ADDENDUM TO  
FUEL DENSIFICATION - INDIAN POINT NUCLEAR GENERATING  
STATION UNIT NO. 2

March 22, 1973

Addendum to "Fuel Densification - Indian Point Nuclear Generating Station Unit No. 2" (January, 1973)

FIGURE 3.10-1 CONTROL BANK INSERTION LIMITS  
FOR 4 LOOP OPERATION

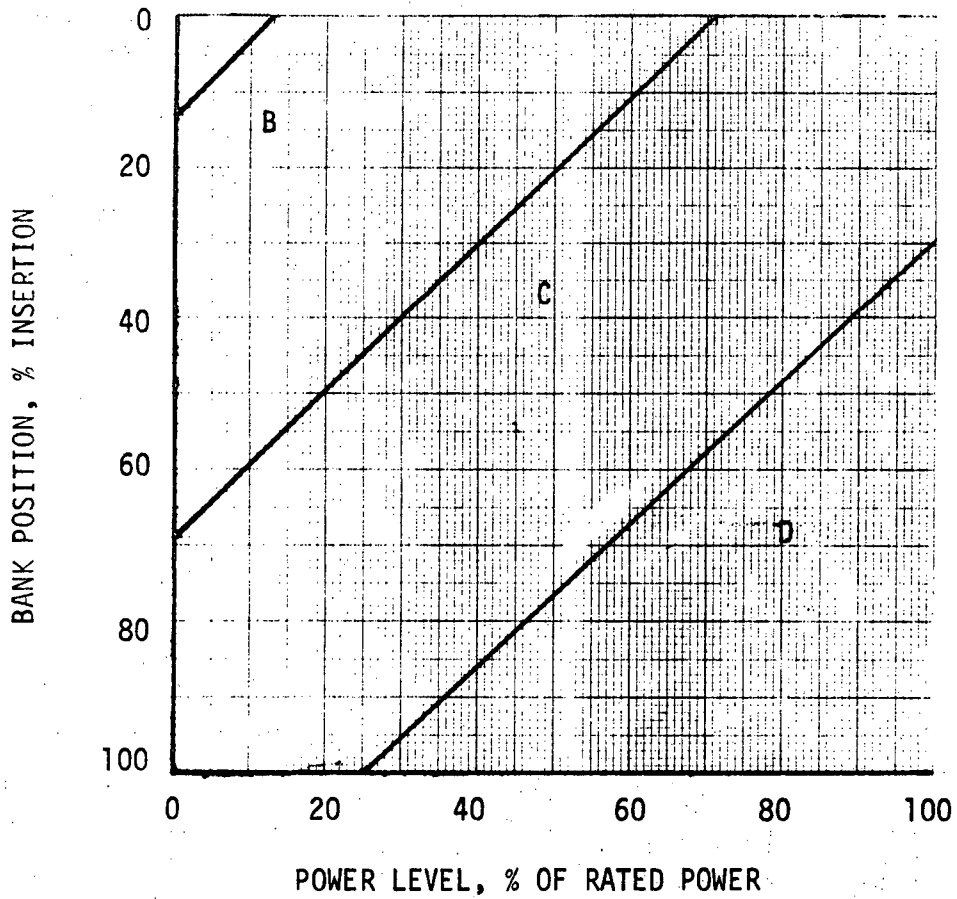
- a. The control rod insertion limits must be revised as indicated below in the revision for Section 7.0. This

Changes to the Technical Specifications are contained on the revised pages 7-2, 7-3, 7-4 and 7-6 and the revised Figures 3.10-1 and 3.10-2.

FIGURE 4.2 TOTAL HEAT FLUX PEAKING FACTOR -  $F_Q$  VS AXIAL OFFSET

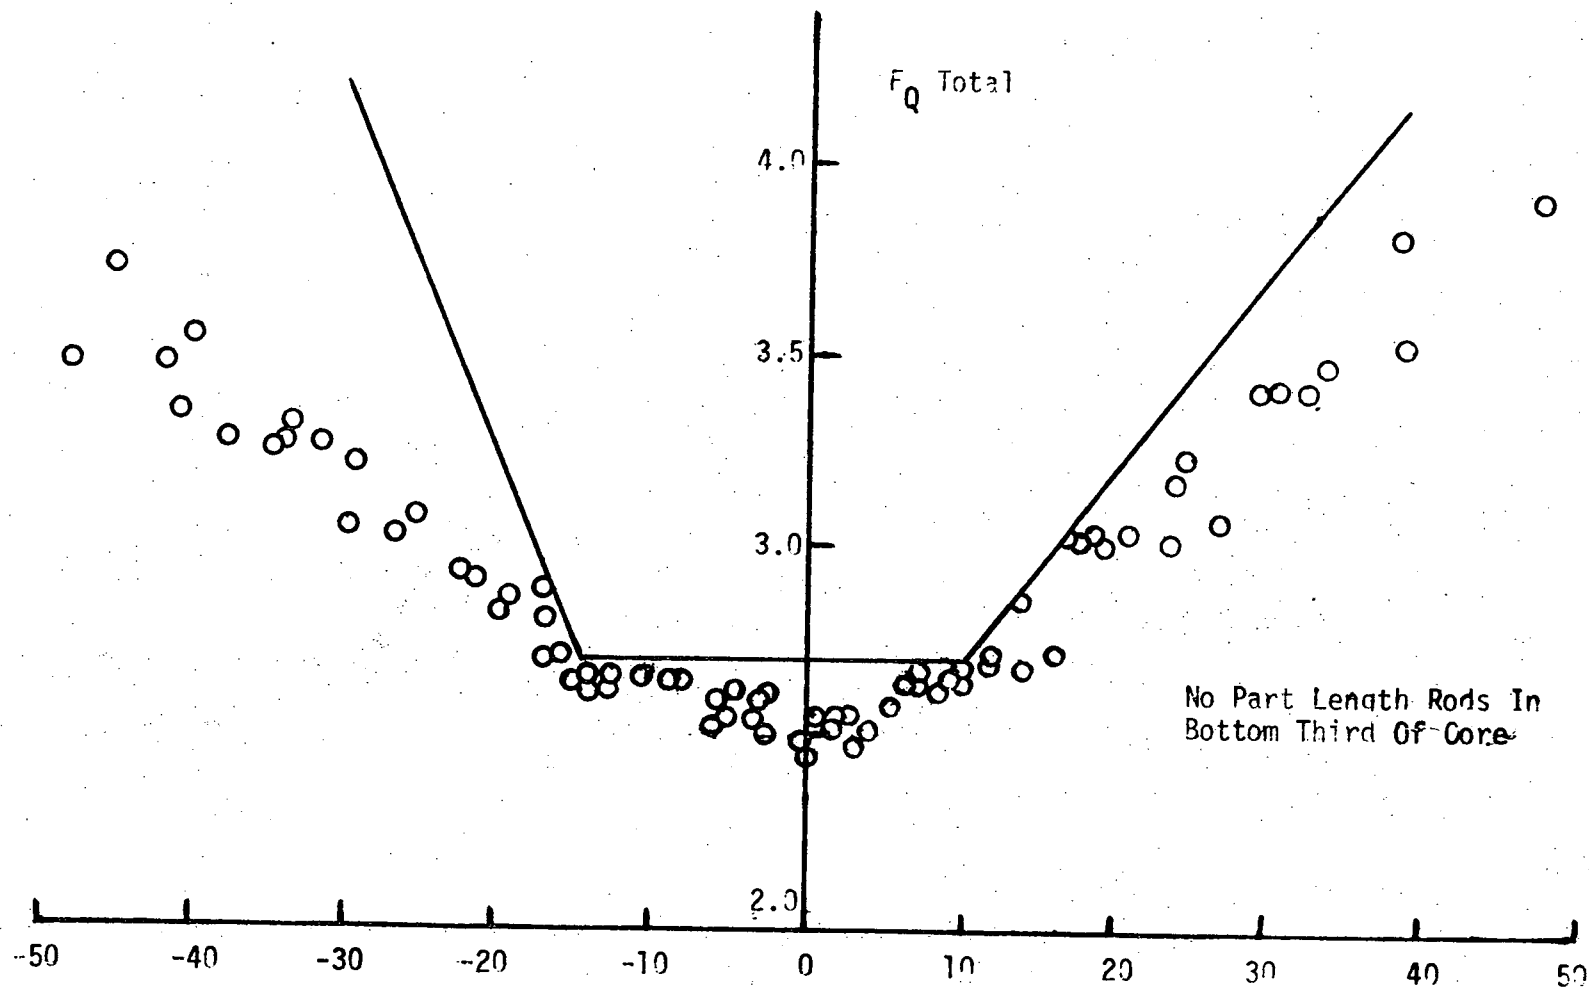
Since the issuance of the Indian Point Unit No. 2 Fuel Densification Report, the  $F_Q$  vs. axial offset correlation, which was presented in Figure 4.2, has been re-evaluated on a basis consistent with Attachment 3 of Westinghouse letter NS-SL-524 to D. Knuth from R. Salvatori, dated January 2, 1973. The methods employed for the results presented below are the same as in the original IPP 2 analysis, but with more control rod maneuvers and resultant transients considered. The same margins for uncertainty and manufacturing tolerances are included as in the previous analysis. As in the previous analysis, the axial power peaking factor and a horizontal peaking factor,  $F_{xy}$ , at the plane of the peak local power no lower than 1.44 were also incorporated. This new correlation is shown in the revised Figure 4.2 and necessitates the following changes in operating procedures to assure conformity to the assumptions of the revised analyses.

The re-evaluation indicates that a total peaking factor,  $F_Q$ , of 2.70 is still maintained by reference only to the ex-core detector axial offset.
